COMMITTEE Correspondence

Name of Committee: Human Accommodations and Design Devices (HADD)

SUBJECT: Head Restraints: GTR7 ph2, Static Backset Measurement proposal by OICA

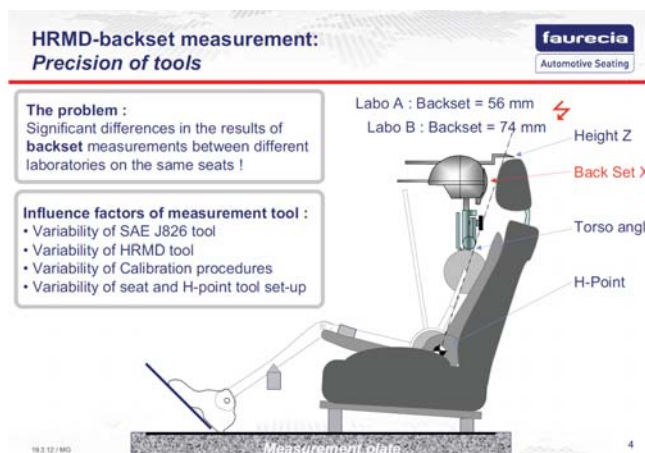
The SAE HADD committees, VDA, GTR7, OICA and other groups have investigated improving the static head restraint measurement methods now employed to measure backset. A measurement solution employing the use of coordinate measuring machines (ex. Faro Arm) in combination with the SAE J826 H-point machine has been recognized as a possible technique to replace the use of the ICBC HRMD. The reason for pursuing new measurement methods has been documented by many groups, but more recently by Faurecia. Their backset measurement report is contained within the letter sent to me by the VDA and it is attached to this email, but briefly stated, their results are as shown in the following screen capture.

Suffice it to say that backset measurement variation occurs from several sources when the ICBC fixture is coupled with the J826 manikin, primarily because the SAE J826 was never designed to be used with the ICBC HRMD. Further, J826 is an H-pt location device such that adding anything on to the J826 influences the validity of the resultant H-pt. In this regard, SAE HADD committee welcomes and supports proposals such as that received from OICA on 6/15/2012, but since we received this proposal after our 6/14/2012 meeting the entire membership has not had the opportunity to review and comment.

Summary: The HADD committee appreciates the opportunity to review and comment on GTR-7 activities related to use of the J826 H-pt manikin and its use in proposed head restraint backset measurement methods. To this end the HADD committee fully supports going away from using the ICBC HRMD as a measurement method and welcomes the cooperative atmosphere conveyed by the VDA, GTR7, OICA and other members of the international community involved in this activity.
